Access Compliance Report

Public Rights-of-Way (Curb Ramps)

Intersection ID: 2903	Main Street: FOGGY_MEADOW_RD	Cross Street: RED_CLOVER_LN	Location:	SW
ADA ID: 8CC4CC5A6404	Ramp Type: Perp	Initial Pass/Fail: Pass	Overall Compliance: No	Severity Score: 7.5

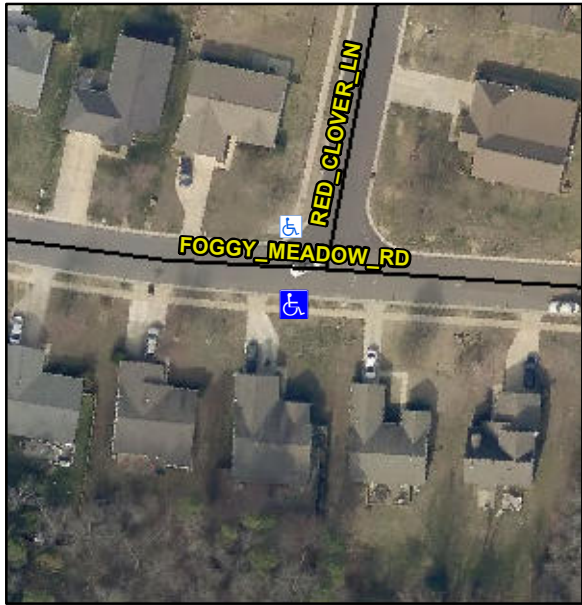
Codes/Mitigation Info/Possible Solution			Field Measurements/Component Compliance					
	Possible Solutions:		Compliance	Description	Data	Compliance	Description	Data
	Remove & Replace Gutter.		N/A	Ramp Length (in)	47.0	Yes	Ramp Slope (%)	7.2
			Yes	Ramp Width (in)	60.0	Yes	Ramp XSlope (%)	1.3
			N/A	Flare Type LT	Sloped	N/A	Flare Type RT	N/A
			N/A	Flare Slope LT (%)	0.7	N/A	Flare Slope RT (%)	7.2
			N/A	Flare Traversable LT?	No	N/A	Flare Traversable RT?	No
			Yes	Landing Length (in)	48.0	Yes	DWS Provided?	Yes
			Yes	Landing Width (in)	48.0	Yes	DWS Contrast?	Yes
			Yes	Landing Slope (%)	0.2	Yes	DWS Length (in)	24.0
			Yes	Landing X Slope (%)	1.5	Yes	DWS Full Width?	Yes
Surveyor Notes:		N/A	N/A	Landing Curb? (Y/N)	No	Yes	DWS Offset (in)	1.0
PROW/ADA:		R302.7.2, R304.5.3	N/A	Shared Landing?	No			
			Yes	Gutter Ponding?	No	Yes	Gutter Slope (%)	4.6
			No	Gutter Lip Ht (in)	0.5	No	Gutter X Slope (%)	3.4
			N/A	Painted X Walk1?	No	N/A	Painted X Walk2?	N/A
